Notice of Intent

Type of Action: APD Change

Procedure Description: XTO respectfully requests approval to make the below listed changes to the approved APDs. 1. Casing design to be changed from the “4-String Design – Engineered Weak Point” (FIGURE F) to the “4-String Design – Open 1st INT x 2nd INT Annulus” (FIGURE D). An open annulus will be utilized and monitored during completions operations. Post completion, bradenhead squeeze will be performed to tie back the 1st intermediate x 2nd intermediate annulus. TOC will be placed into the 1st intermediate shoe but still below the base of Potash interval. 2. No changes to the cementing, casing or mud circulating system designs will be required for the requested change. 3. There is no new surface disturbance. Please refer to the R-111-Q well bore diagrams in the attachment reflecting the changes requested. WELL NAME API Number JRU Apache Federal Com 114H 30-015-55830 JRU Apache Federal Com 115H 30-015-55831 JRU Apache Federal Com 804H 30-015-55853 JRU Apache Federal Com 904H 30-015-55858 JRU Apache Federal Com 709H 30-015-56190 There is no new surface disturbance.

WELL NAME	API Number
JRU Apache Federal Com 114H	30-015-55830
JRU Apach

Previous Design: 4-String Design – Engineered Weak Point**[Figure F] 4 String – 2nd Intermediate casing engineered weak point**

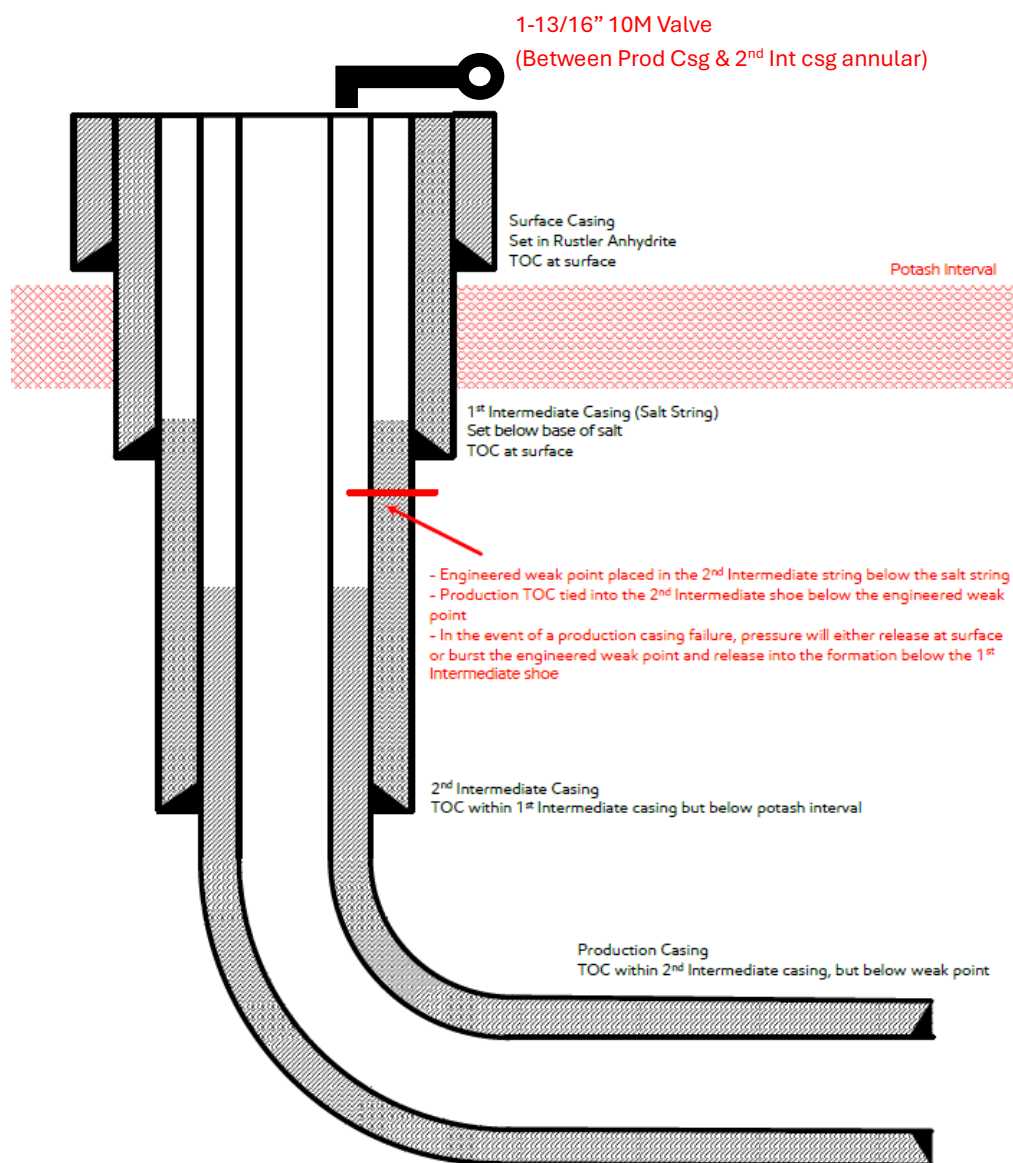
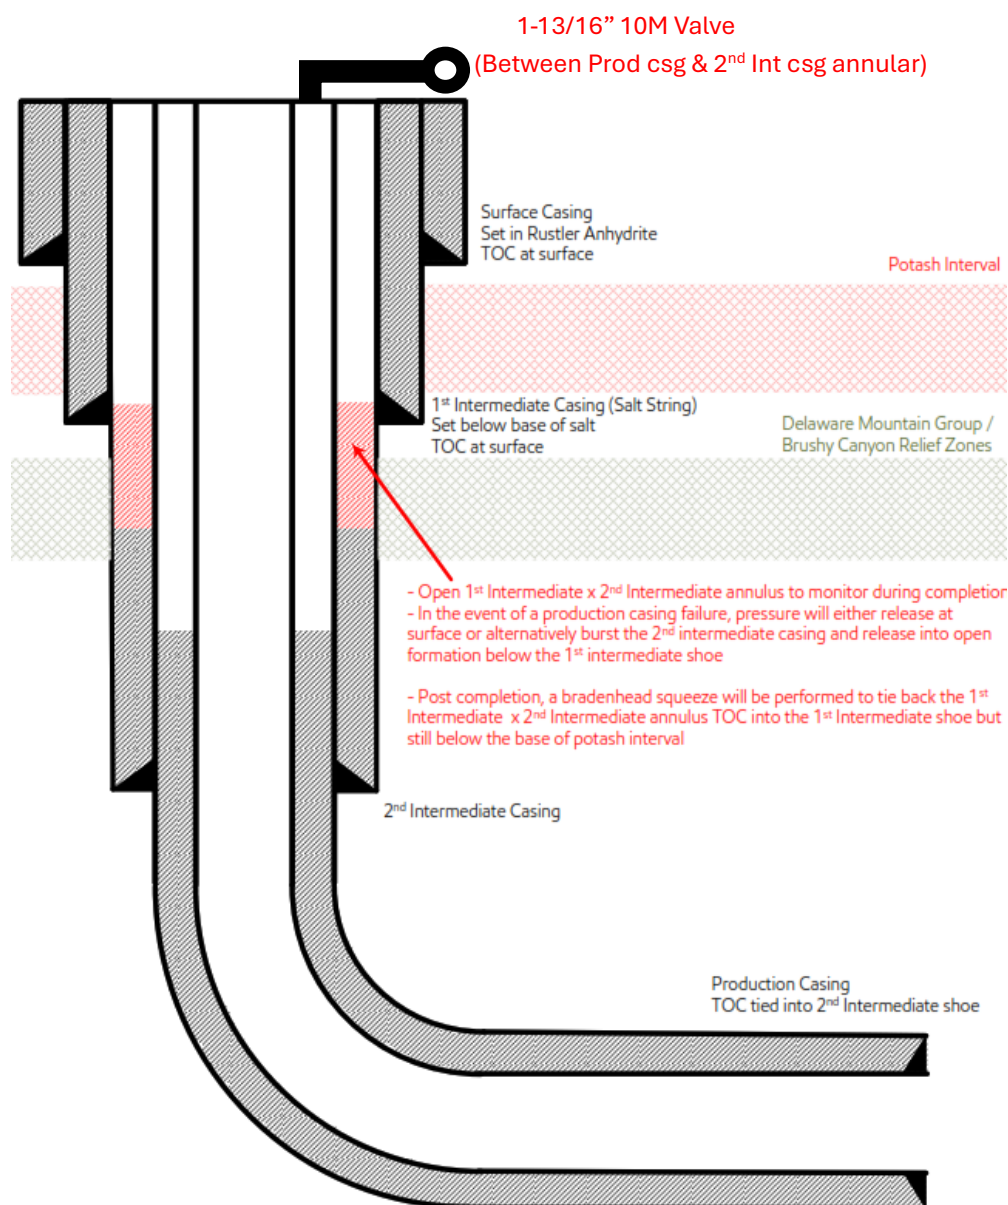
1. Casing design to be changed from the "4-String Design – Engineered Weak Point" (FIGURE F) to the "4-String Design – Open 1st INT x 2nd INT Annulus" (FIGURE D). An open annulus will be utilized and monitored during completions operations.

Post completion, bradenhead squeeze will be performed to tie back the 1st intermediate x 2nd intermediate annulus. TOC will be placed into the 1st intermediate shoe but still below the base of Potash interval.

2. No changes to the cementing, casing or mud circulating system designs will be required for the requested change.

Please refer to the R-111-Q well bore diagrams attached below reflecting the changes requested.

- 1) Alignment with KPLA requirements per schematic per schematic below, with engineering weak point casing design and utilizing new casing that meets API standards.
- 2) Contingency plans in place to divert fluids away from salt interval in event of production casing failure.
- 3) Intermediate 2 casing will consist of a primary cement job with TOC at the top of the Brushy Canyon formation within the Delaware Mountain Group.
 - a. Bradenhead squeeze to be completed after primary cement job to tie back TOC to intermediate 1 "Salt string" at least 500' but with top below Marker Bed 126 "Potash Interval".
- 4) Production cement to be tied back no less than 500' inside previous casing shoe (intermediate 2 casing) and below the engineered weak point.

- 1) Alignment with KPLA requirements per schematic above, leaving open annulus open for pressure monitoring during frac and utilizing new casing that meets API standards.
- 2) Contingency plans in place to divert fluids away from salt interval in event of production casing failure.
- 3) Intermediate 2 bradenhead squeeze to be completed within 180 days to tieback TOC to salt string at least 500ft but with top below Marker Bed 126.
- 4) Production cement to be tied back no less than 500ft inside previous casing shoe.
